Subject: Oconee Nuclear Station
Docket Numbers 50-269, 270, and 287
Supplement to License Amendment Request
associated with the Passive Low Pressure
Injection Cross Connect Modification
Technical Specification Change (TSC) Number
2003-02

RAI's FOR OCONEE AMENDMENT REQUEST

Figure 1. True Stress - True Strain for Type 304SS at 75°F

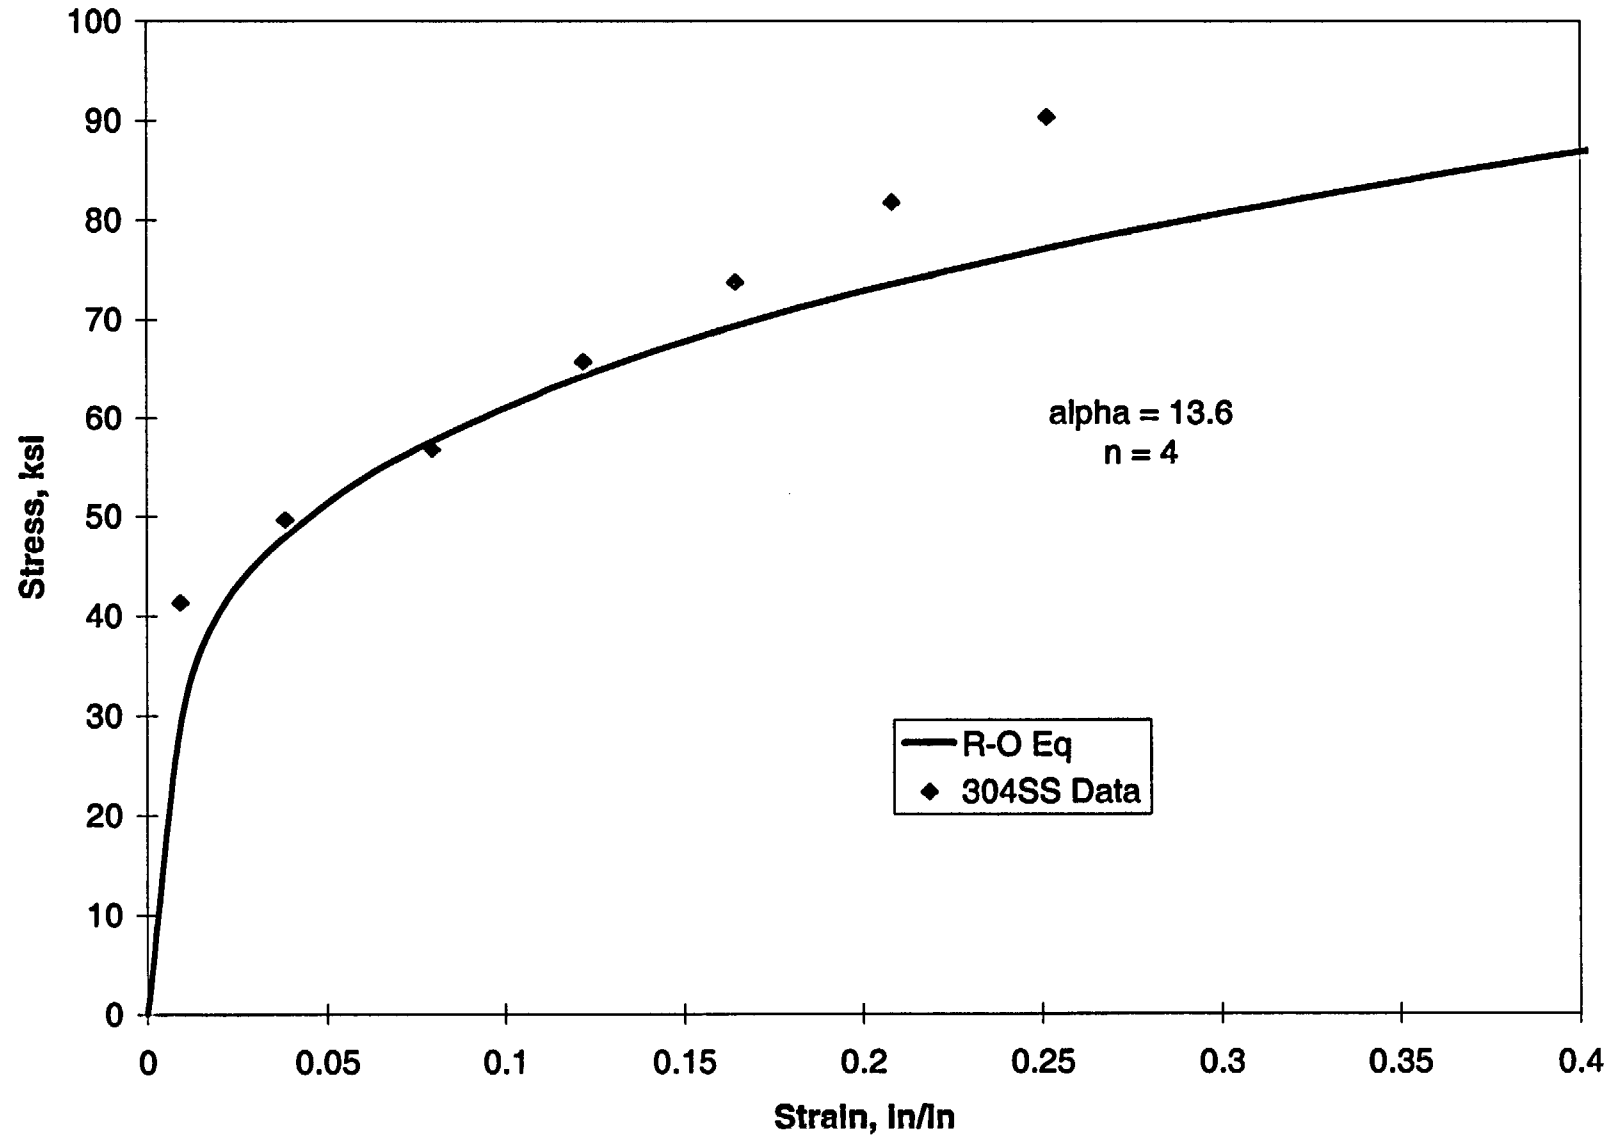
RAI-6 Figure 3-1 is meant to show the Ramberg-Osgood stress-strain equation fit to the experimental data of Reference 11, but it shows, instead, the fit of a J-R curve. Provide a revised Figure 3-1.

RESPONSE The LBB topical report has been revised to include the revised figure (See attached Figure 1).

Figure 2. Leakage Size Cracks Considering Various Ramberg-Osgood Parameters at Piping Location 2

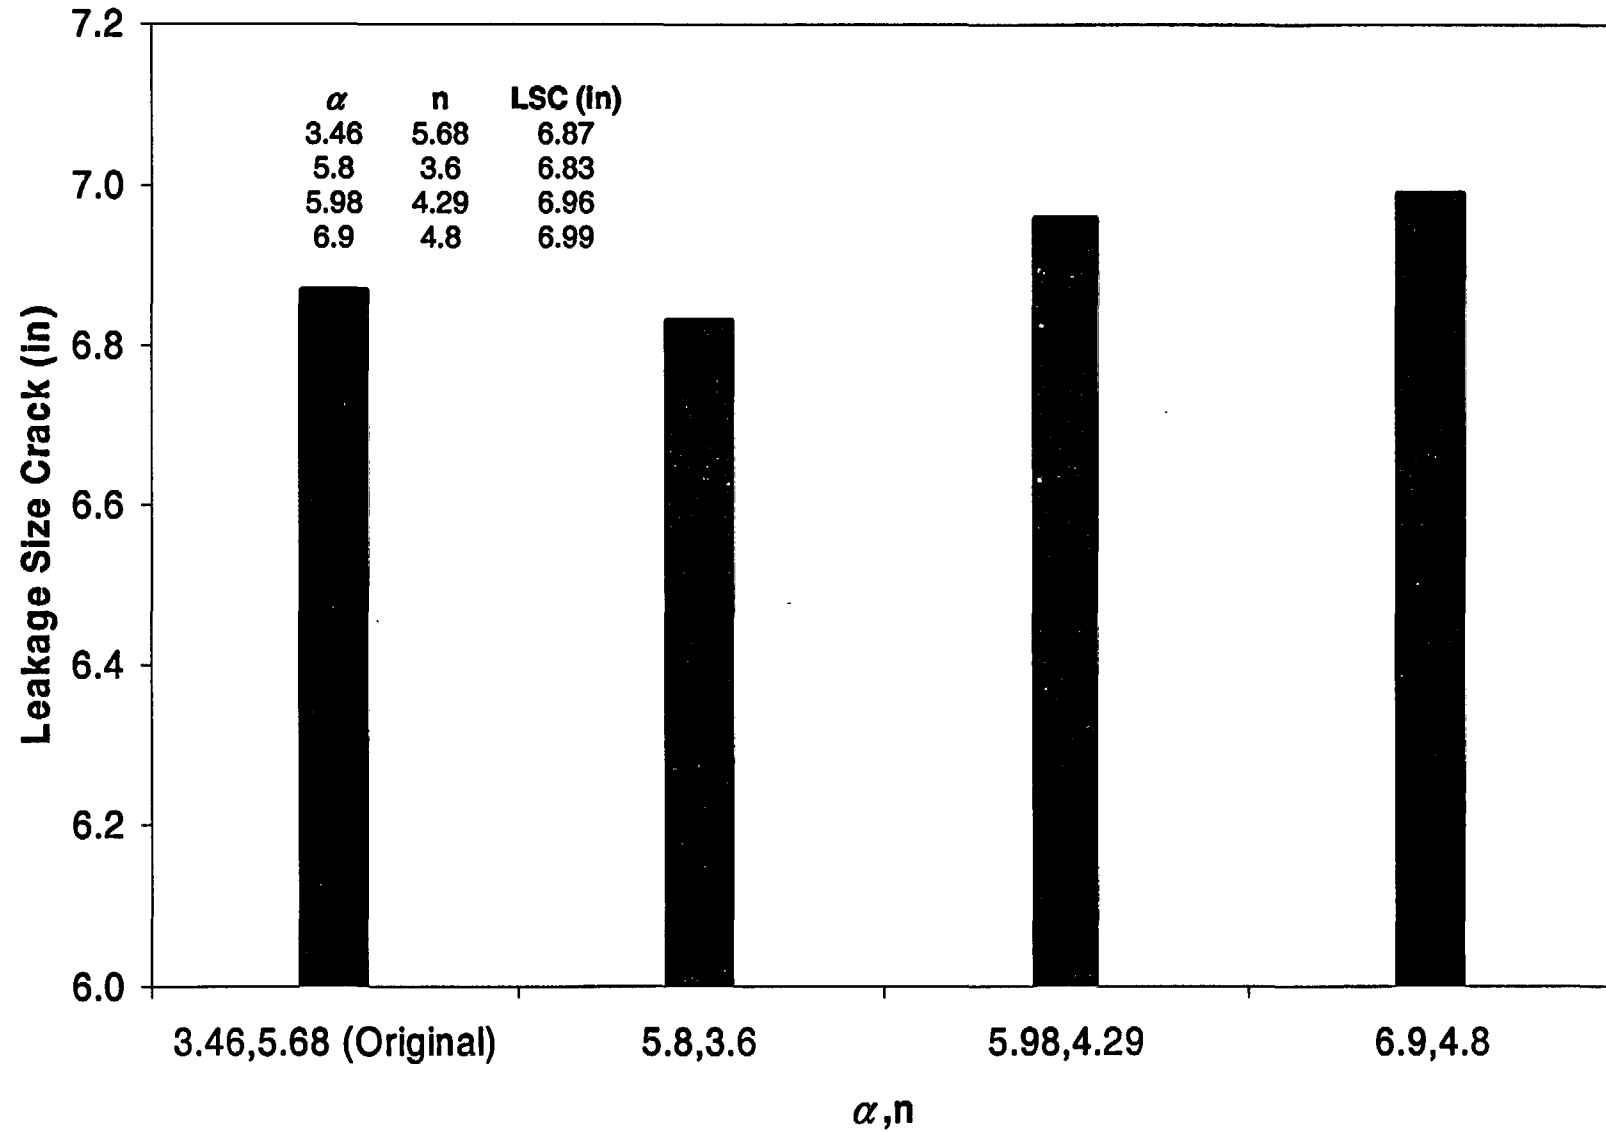
RAI-7 The Ramberg-Osgood parameters for the same material from different sources may be quite different. For instance, you reported (α, n) of (8.0, 3.5) for 304 stainless steel (SS) base metal and (α, n) of (0.565, 8.28) for 316 stainless steel base metal at 550°F. However, the Ramberg-Osgood parameters are reported to be (5.98, 4.29) for 304 SS base material in EPRI NP-3596-SR, Revision 1, "PICEP: Pipe Crack Evaluation Program (Revision 1)," and (6.9, 4.8 or 5.8, 3.6) for 316 SS base material in an NRC safety evaluation, "Staff Review of the Submittal by Rochester Gas and Electric Company to Apply Leak-Before-Break Status to Portions (of) the R.E. Ginna Nuclear Power Plant Residual Heat Removal System Piping [TAC NO.: MA0389]," dated February 4, 1999. Assess the impact to margins on flaw size due to uncertainty of (α, n) at such a magnitude. The assessment should include all materials in Table 7-1 of your submittal.

For piping location 2, the R-O parameters for both the 304 SS (5.98, 4.29) and 316 SS materials (6.9, 4.8 or 5.8, 3.6) were considered to conservatively bound the 316 SS material at the location. As depicted in Figure 2, the predicted 10 gpm leakage crack sizes ranged from 6.83 inches to 6.99 inches. Therefore, the maximum leakage crack size of 6.99 inches (obtained using α , and n values of 6.9 and 4.8, respectively) is conservatively considered in this assessment.

Figure 3. J versus T Diagram for 304SS Base Metal at LBB Location 1

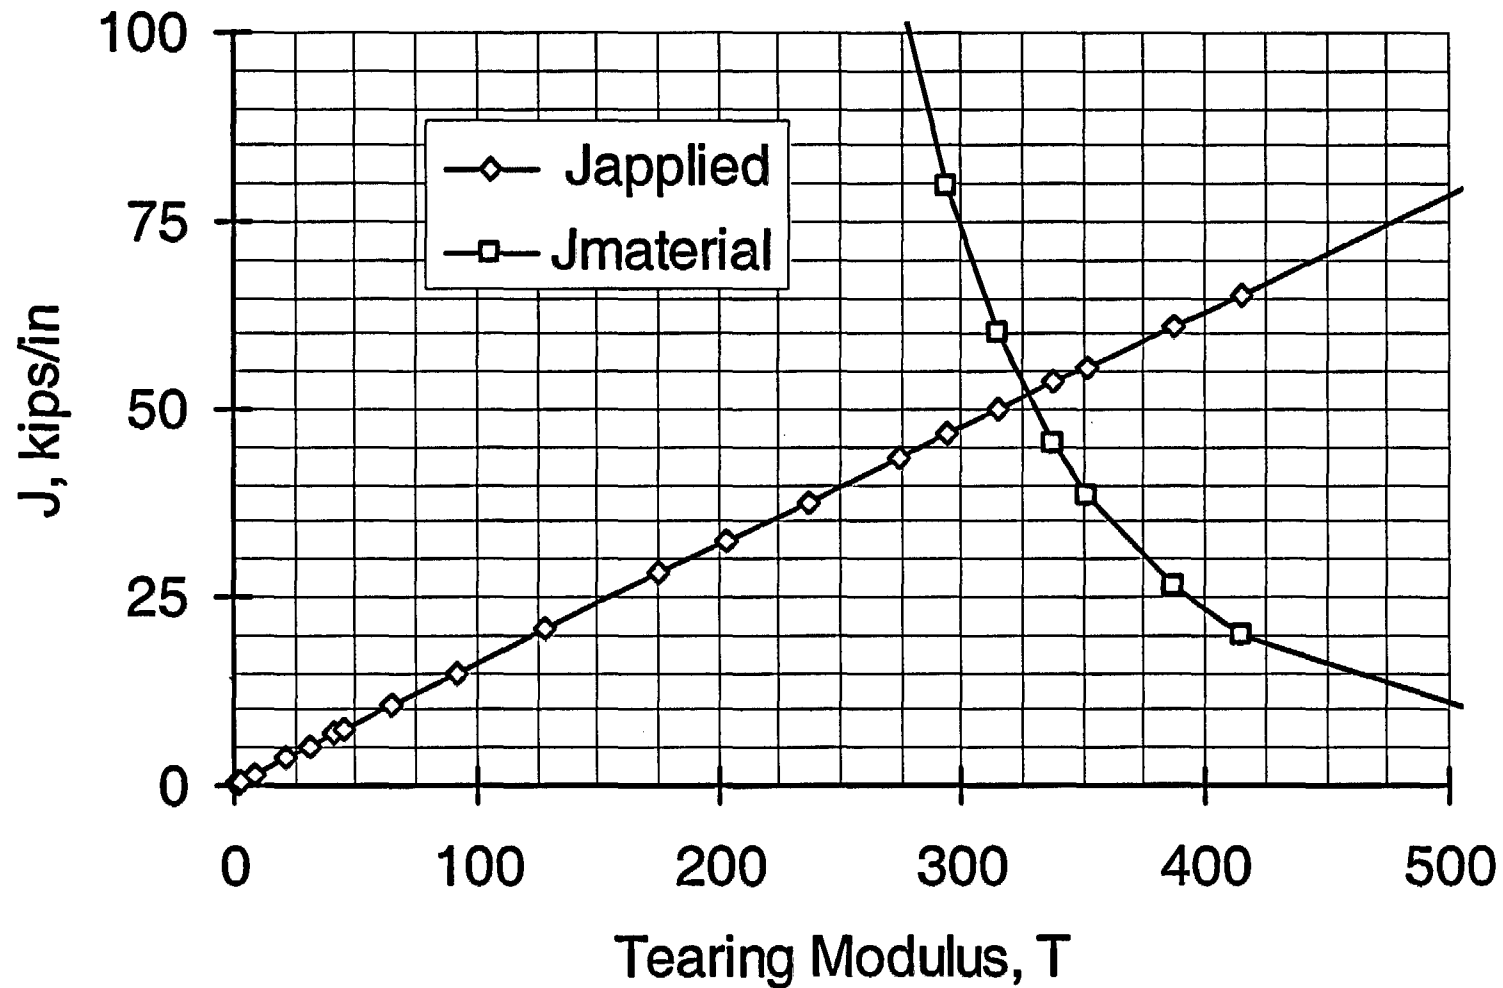
RAI-9 The J-T analysis has become a little complex by your consideration of an additional parameter $J_{upper\ limit}$. Explain the need to have $J_{upper\ limit}$ included in your stability analysis.

RESPONSE In the J-T Analysis summarized in the topical report, Framatome ANP considered an additional limit on J, called $J_{upper\ limit}$, which is less than $J_{instability}$ in a J-T analysis, as an added conservatism. $J_{upper\ limit}$ is based on the J at maximum crack extension from an actual compact test specimen. This approach is eliminated when performing the new J-T analysis whose results are reported in Tables 1 and 2 and Figures 3 through 7.
